Subject: Marymount California University – 6-Month Review of the Expanded Parking Lot Project (Planning Case No. ZON2003-00317)

Location: 30800 Palos Verdes Drive East

TO: HONORABLE MAYOR & CITY COUNCIL MEMBERS
FROM: JOEL ROJAS, AICP,  COMMUNITY DEVELOPMENT DIRECTOR
DATE: FEBRUARY 18, 2014
SUBJECT: MARYMOUNT CALIFORNIA UNIVERSITY – 6-MONTH REVIEW OF THE EXPANDED PARKING LOT PROJECT (PLANNING CASE NO. ZON2003-00317) / 30800 PALOS VERDES DRIVE EAST)
REVIEWED: CAROLYNN PETRU, ACTING CITY MANAGER 
Project Manager: Ara Mihranian, AICP, Deputy Community Development Director

SHOWS PROXIMITY TO CAR NOISE OUT TO DOWNSLOPE NOISE CORRIDOR

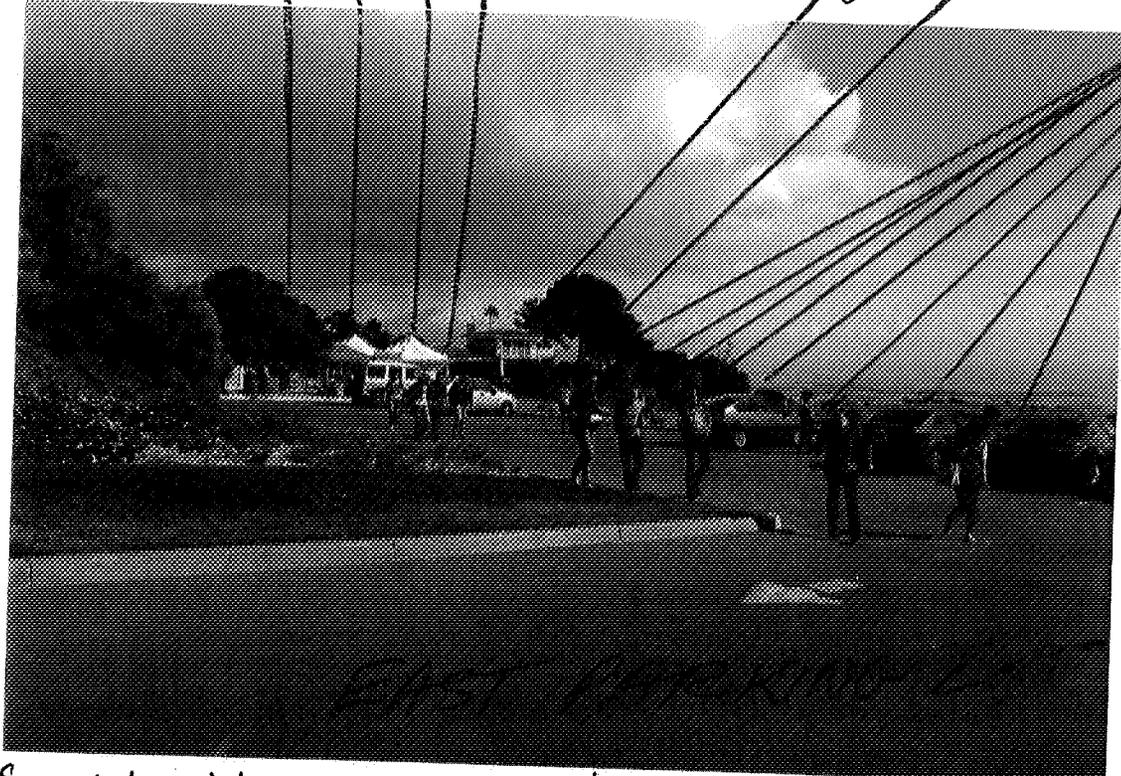
Photo shows RIGHT against / next to SAN RAMON HOMES

PROJECT BETWEEN HOMES & PARKING LOT

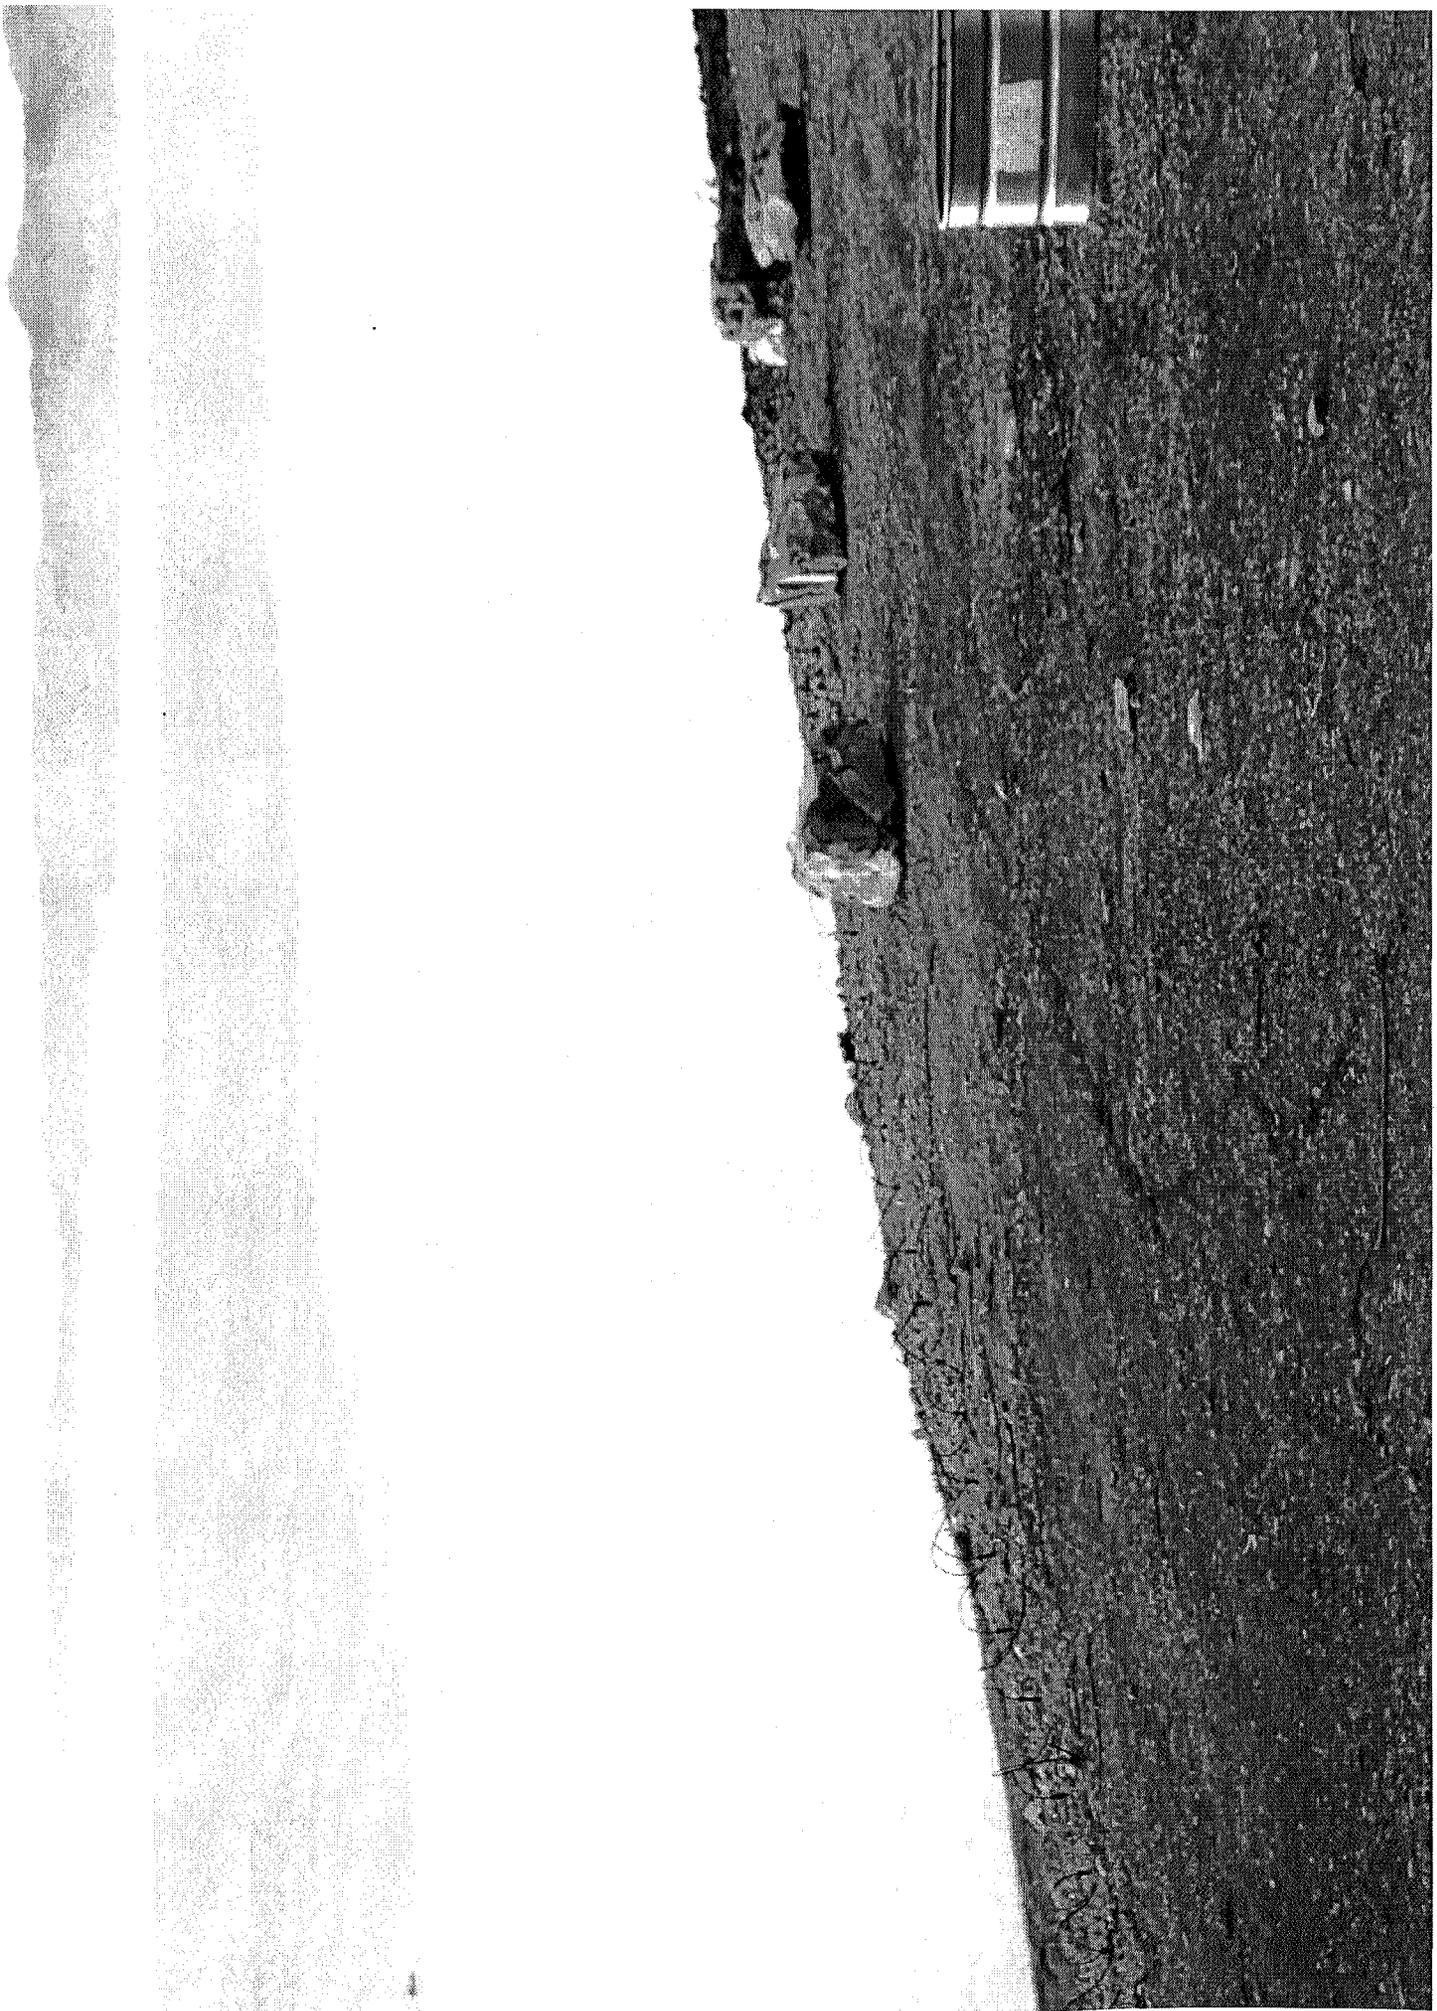
I noticed that there is now a dripline irrigation line running along the edge of the hill by the eastern parking lot. If the landscape plans for that edge are any plant that is higher than a few inches, it will block our ocean view. See attached photo from our deck.
